3Foxes Biodiversity Solutions  
23 De Villiers Road  
Kommetjie  
7975  
03 February 2022

**RE: 132kV power line associated with the Korana Solar Energy Facility near Pofadder, Northern Cape Province - Amendment Application**

**Figure 1.** Map showing the original layout of the grid connection infrastructure associated with the Korana Solar Energy Facility. The map includes Alternative 1B, which is the approved alternative, and Alternative 1A.

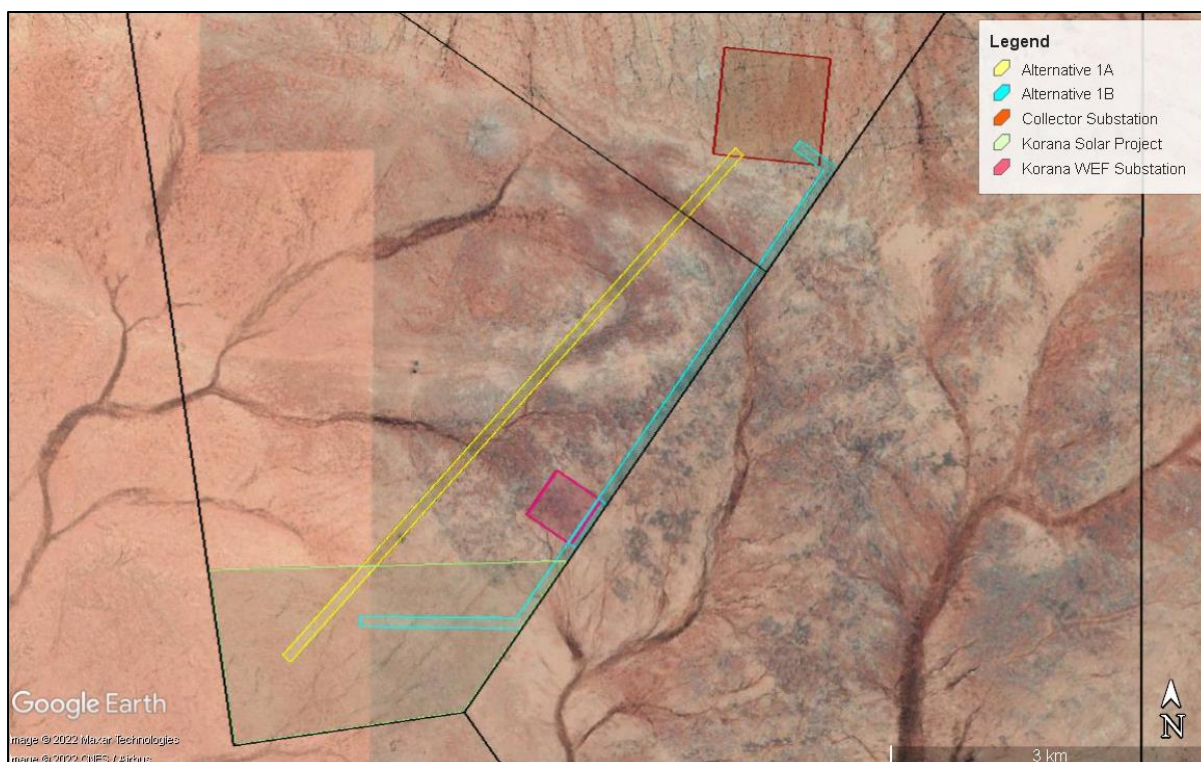
The two grid alternatives traverse a similar set of habitats and there are no significant differences in the ecological sensitivity of the affected habitats along each grid alternative. Alternative 1B is however approximately 600m longer than Alternative 1A. As such, the change in preferred alternative from Alternative 1B to Alternative 1A would not increase either the footprint of the development or the overall assessed impacts associated with the grid connection. In addition, there are not likely to be any new or novel impacts associated with the change in route alternative. The change in preferred alternative is not considered ecologically significant and would not represent a significant change from the original assessment development description. As such, there would not be any changes to the impacts as originally assessed.

As the set of habitats affected and sensitivity of the two routes are similar, there are no significant advantages or disadvantages of the changes that would affect the impacts of the development as assessed. Although Alternative 1A is somewhat shorter than Alternative 1B and as such would potentially generate a lower overall ecological impact. The extent of this difference is not considered ecologically significant.

The change in the preferred grid alternative for the Korana Solar Energy Facility from Alternative 1B to Alternative 1A can be supported from an ecological point of view as the change would not generate novel impacts or increase the severity of existing impacts associated with the Korana PV grid connection. No additional mitigation or avoidance measures, beyond those already recommended in the EIA study are required for the amendment. As such, there are no reasons to oppose the proposed amendment.
